## **REMARKS**

## AMENDMENT TO THE DRAWINGS

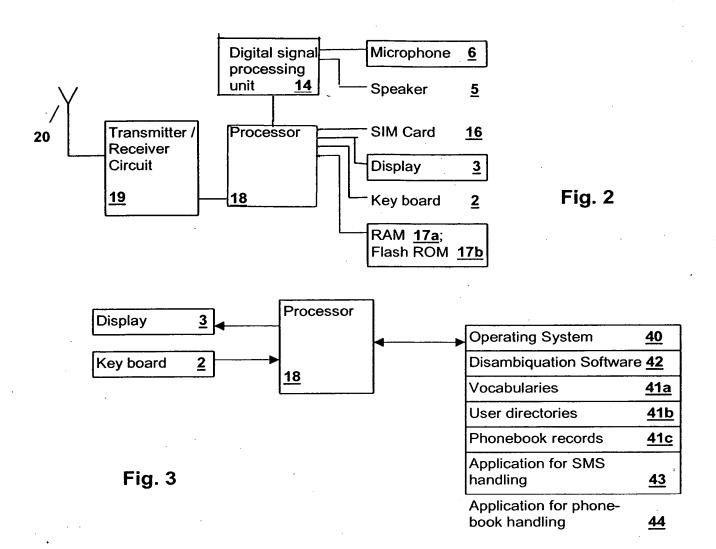
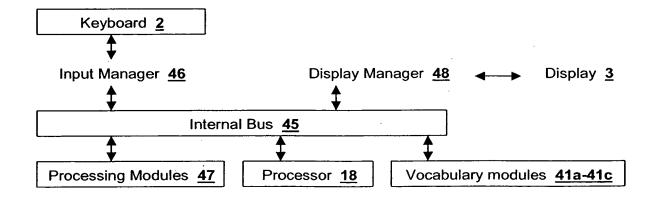
The attached two (2) replacement sheets of drawings include changes to Figs. 2 and 6 thereof. With regard to Fig. 2, the inadvertently omitted outlines of the blocks corresponding to the processor 18 and digital signal processing unit 14 are being appropriately illustrated. The blocks for the processor 18 and unit 14, as now shown by the formal amendments made to Fig. 2, are consistent with the related discussion directed thereto on page 4, line 24 et seq. of the original Specification. With regard to Fig. 6 of the drawings, correction of the misspelled word "character", in two locations, is being effected. Also in Fig. 6, the expression "Press space and add word to text string 105" is being corrected to the expression Press space key 67 and add word to text string 105. The latter revision is of a minor nature and is consistent with the related discussion on page 11, lines 26-27, of the original Specification.
